QUAD 405 Evolution
May 2009

QUAD 405 Schematic as published in Wireless World Dec.1975 to support the article "Current Dumping Audio Amplifier" by P J Walker of the Acoustic Manufacturing Co. Ltd. (QUAD)

Revision: 3	<i>d.c. ~ daylight ltd.</i>	Page Size: A4	<i>d.c. ~ daylight ltd.</i>
M12368 PCBs to DCD Mod-3			5 Greenacre Drive Pontprennau Cardiff CF23 8PA
1 Sept 2008	Drawn: K. Snook	Checked:	Tel: +44 29 20 657149 Fax: +44 29 20 657151
		Page 1 of 1

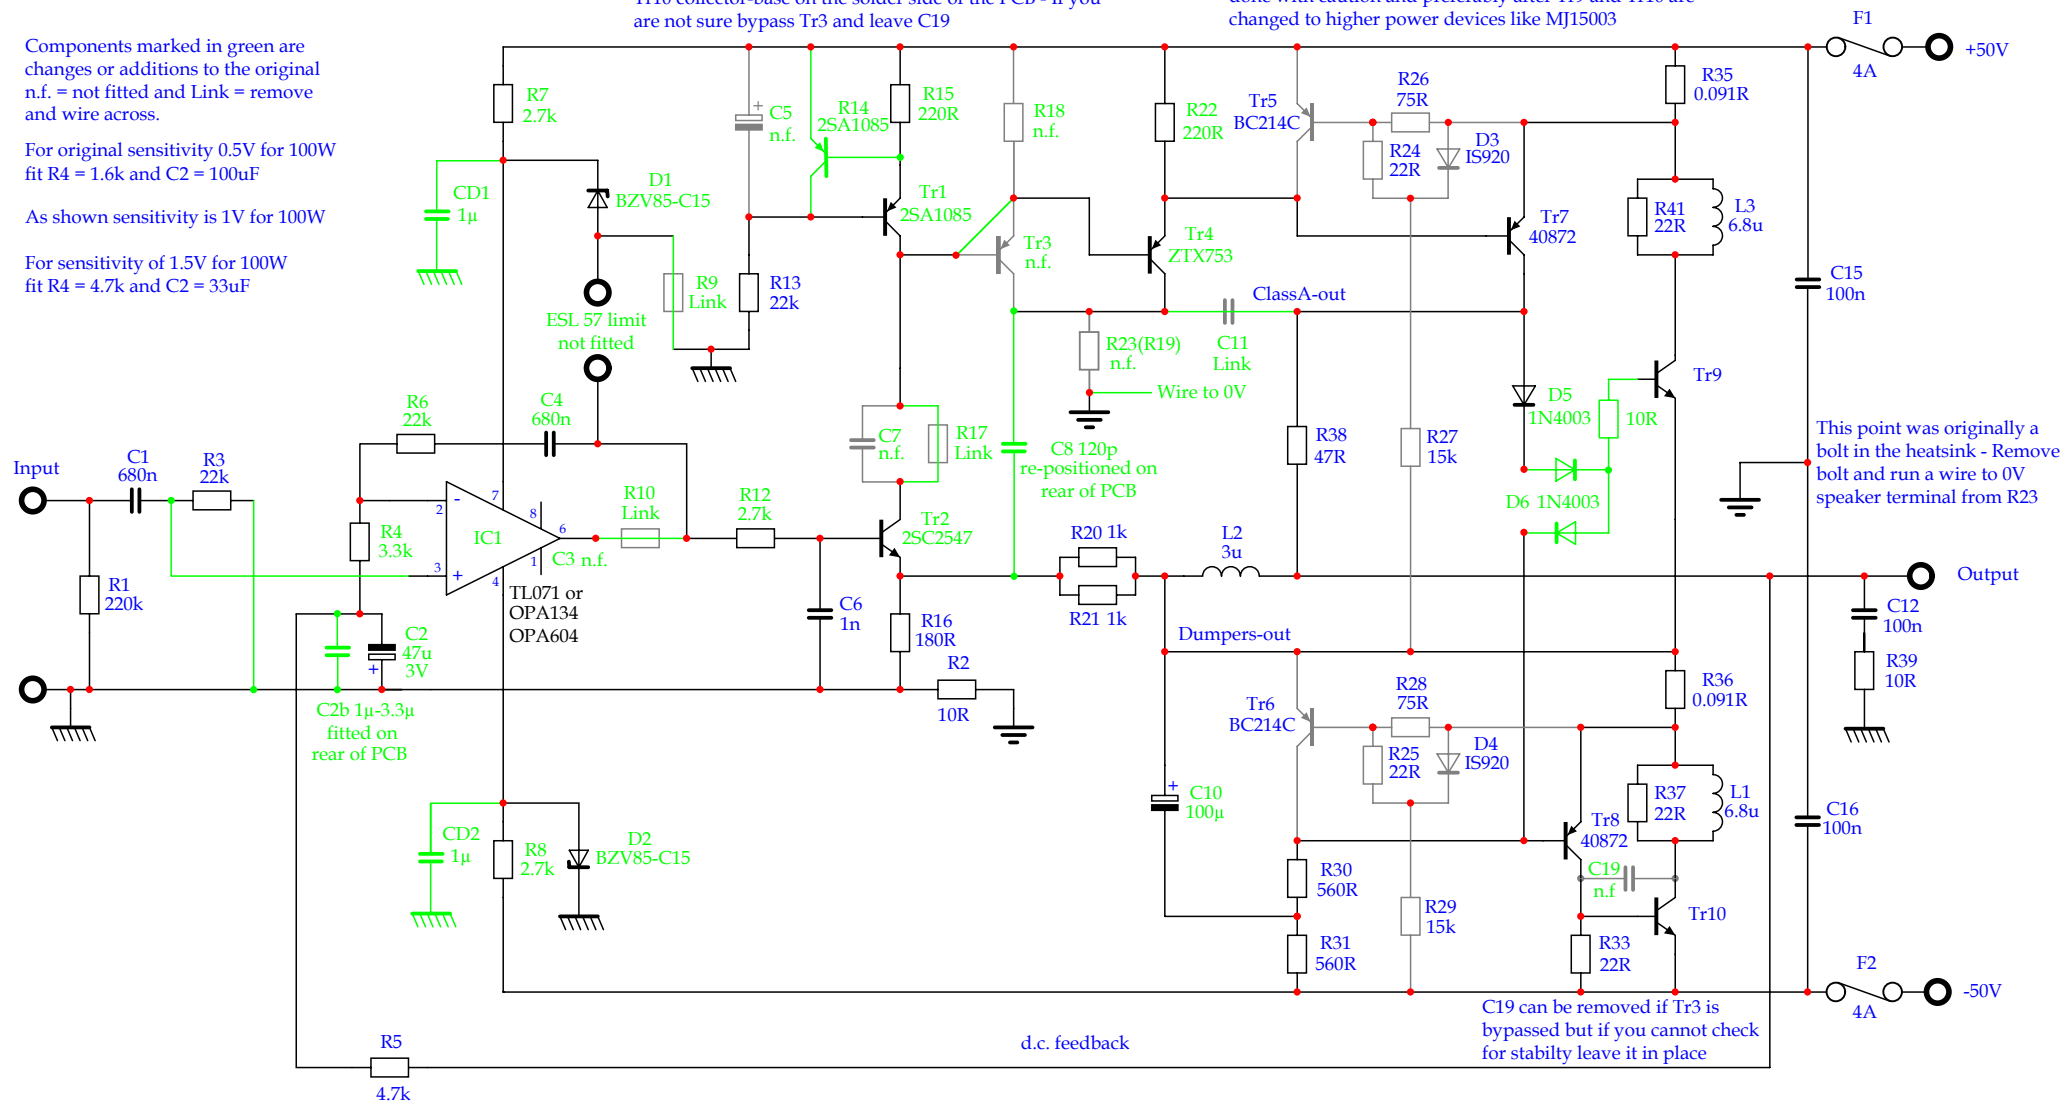
Components marked in green are changes or additions to the original n.f. = not fitted and Link = remove and wire across.

For original sensitivity 0.5V for 100W fit R4 = 1.6k and C2 = 100uF

As shown sensitivity is 1V for 100W

For sensitivity of 1.5V for 100W fit R4 = 4.7k and C2 = 33uF

Tr3 should be bypassed base-emitter as shown and it should then be possible to safely remove C19 fitted across Tr10 collector-base on the solder side of the PCB - If you are not sure bypass Tr3 and leave C19

Components marked in grey with blue reference designators may be removed to disable current limiting - This should be done with caution and preferably after Tr9 and Tr10 are changed to higher power devices like MJ15003

Note the 2 different ground symbols either side of R2 - probably to prevent internal hum loops - The input ground connects to the chassis at the input DIN socket and originally the other side of R2 connects to chassis via the bolt in the heatsink - Even if you do not provide a formal ground wire to the 0V speaker terminal as I show you should ensure that both sides of R2 are at the same potential - If one ground is missing the voltage at the speaker terminals will be about 20mV if both grounds are in place it should be less than 1mV - Both grounds should be connected to chassis

Revision: 2	<i>d.c. ~ daylight ltd.</i>	Page Size: A4	<i>d.c. ~ daylight ltd.</i>
QUAD 405 - DCD Mod-4			5 Greenacre Drive Pontprennau Cardiff CF23 8PA
19 Mar 2005	Drawn: K. Snook	Checked:	Tel: +44 29 20 657149 Fax: +44 29 20 657151
			Page 1 of 1

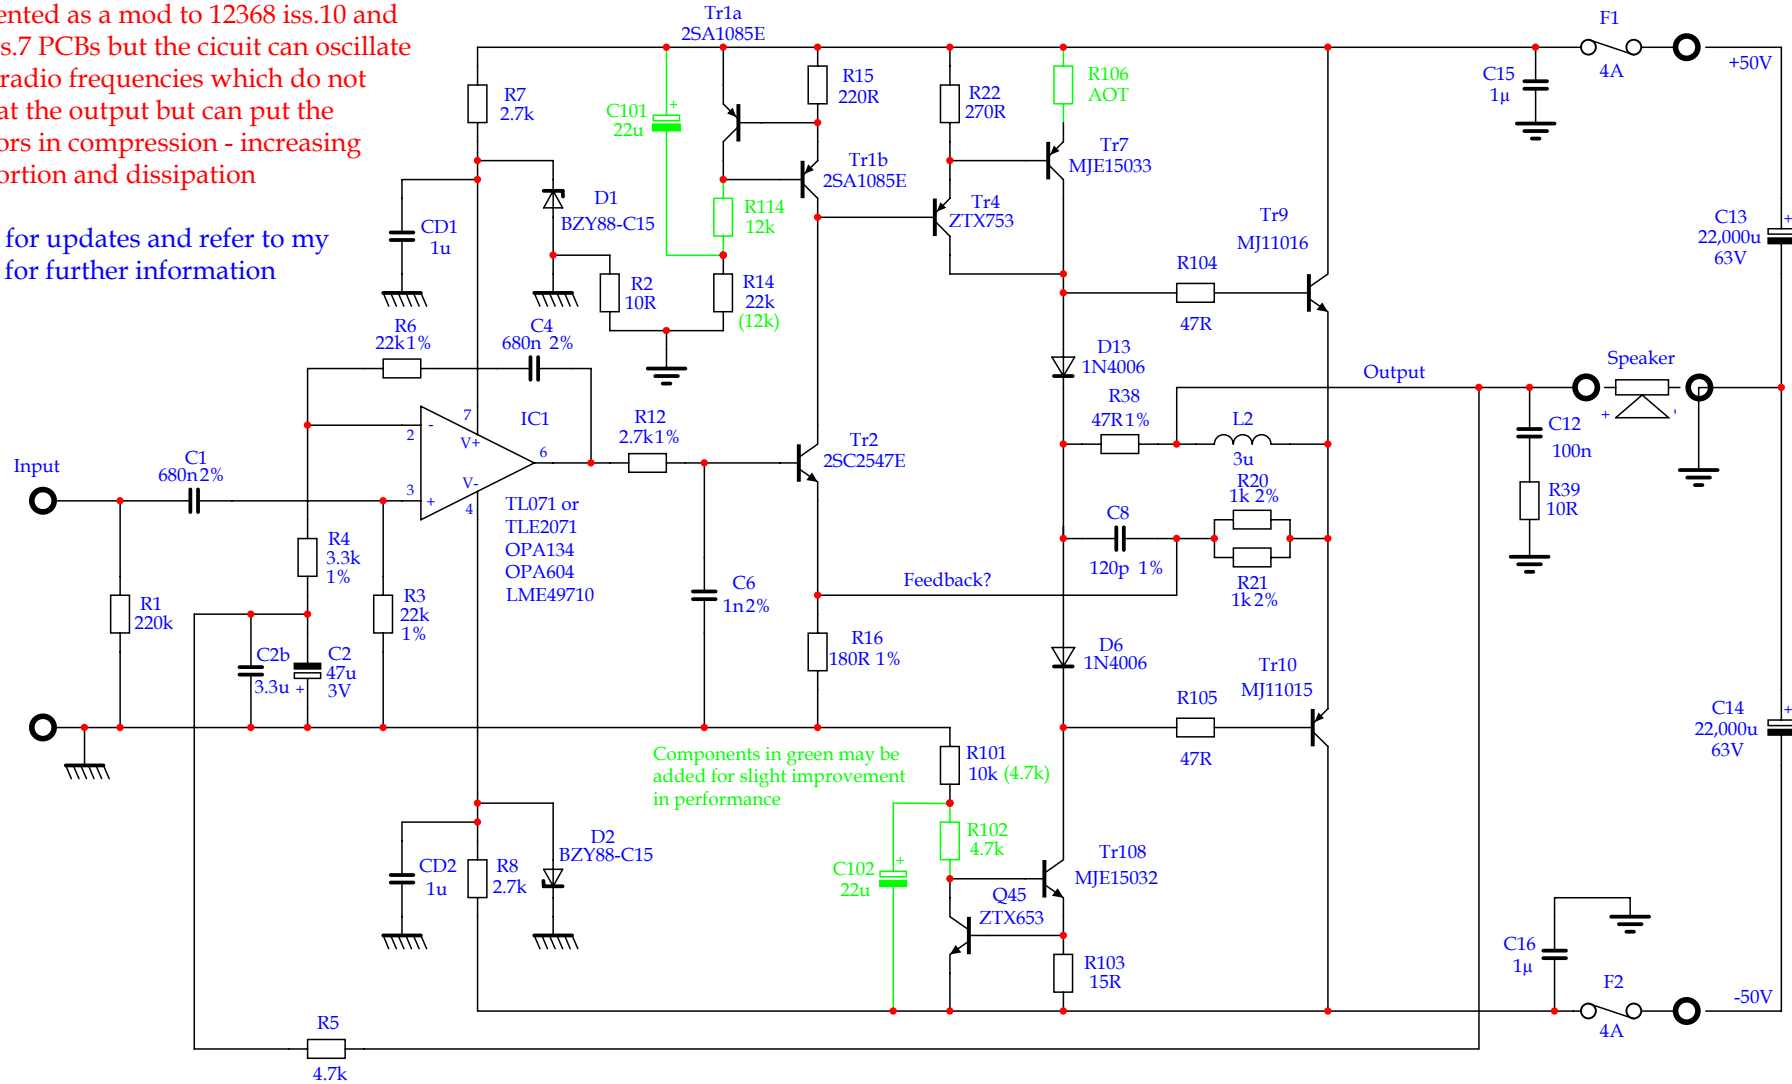
Note: This is only a schematic - It has been implemented as a mod to 12368 iss.10 and 12565 iss.7 PCBs but the circuit can oscillate at VHF radio frequencies which do not appear at the output but can put the transistors in compression - increasing the distortion and dissipation

Components in green may be added for slight improvement in performance

Note: The "Current Dumpers" Tr9 and Tr10 are complimentary Darlington transistors – This layout WILL NOT work with low hfe output devices due to the base current required – The "Current Dumpers" can be made complimentary MOSFETs If D13 and D6 are changed for resistors but care must be taken to ensure that the Source-gate voltage can be obtained within the limits of Tr7 and Tr108 current drive
